PARTS CATALOGUE

SNOWMOBILE

VX750S 1992 SERVICE/HIGH ALTITUDE DATA

TECHNICAL BULLETIN

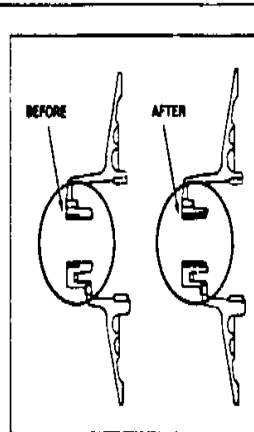
3. Using a lathe, machine the center bushing bore of the sliding sheave all the way through as represented to the right. Actual machining specifications are provided on the last page of this bulletin. Chamfer both ends of the bore, and lightly sand the bore with 400 grit sandpaper to remove machining imperfections.

The large sliding bushing (torque cam bushing) remains in the sliding sheave during this machining process. Be careful to avoid damage to this bushing. If this bushing would be damaged during the machining of the center bushing bore, replacement would be necessary.

4. Apply blue Loctite to the outer circumference of the new center bushing. Using a press, install the bushing into the bore of the sliding sheave. Be sure that when you press the bushing in that it is in line with the bore. Press the bushing in until the bushing surface is flush with the aluminum surface on the outside of the sheave.

PER BULLETIN S92-001

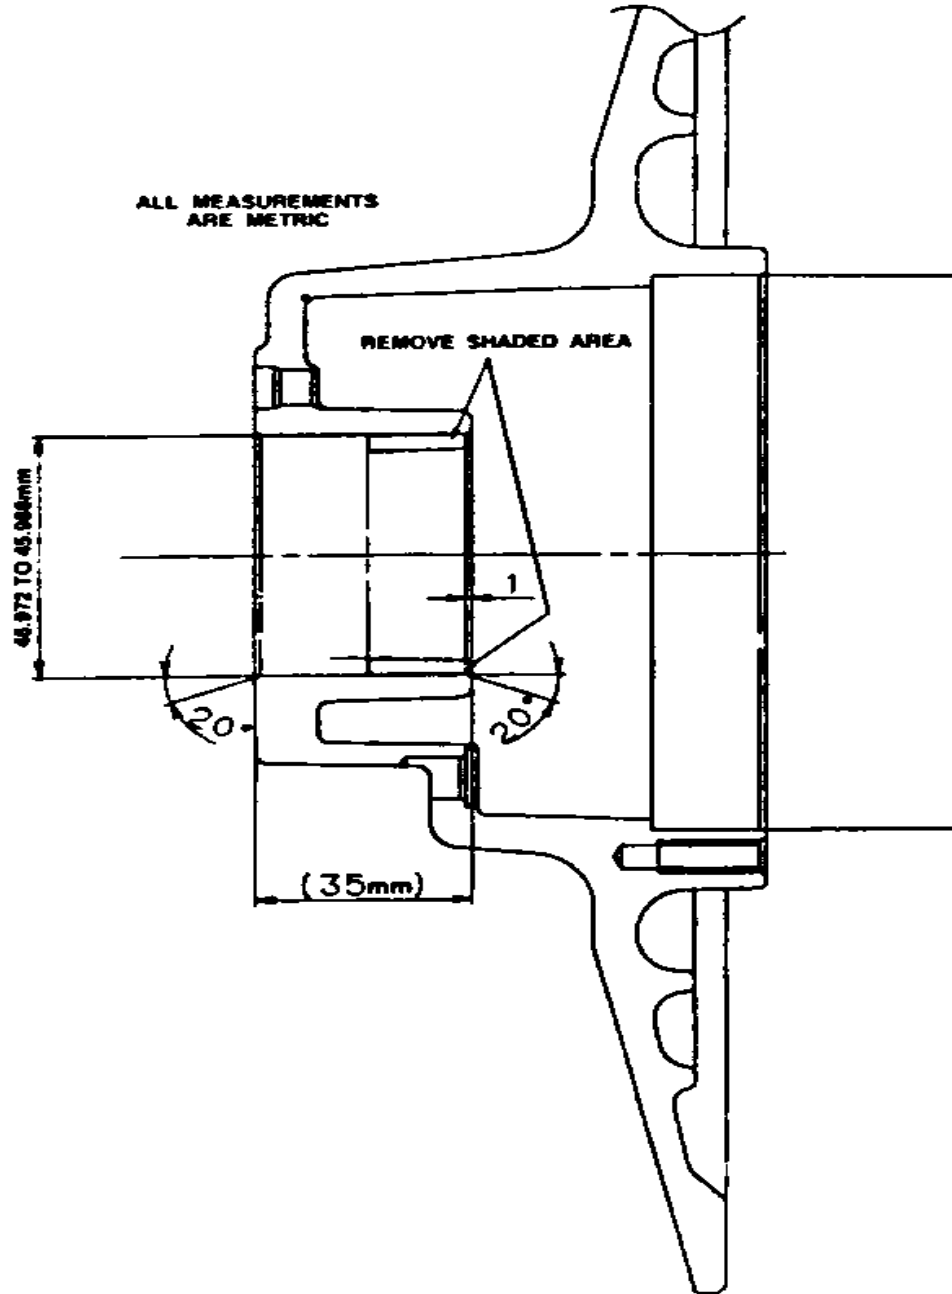
REMOVE SHADED AREA
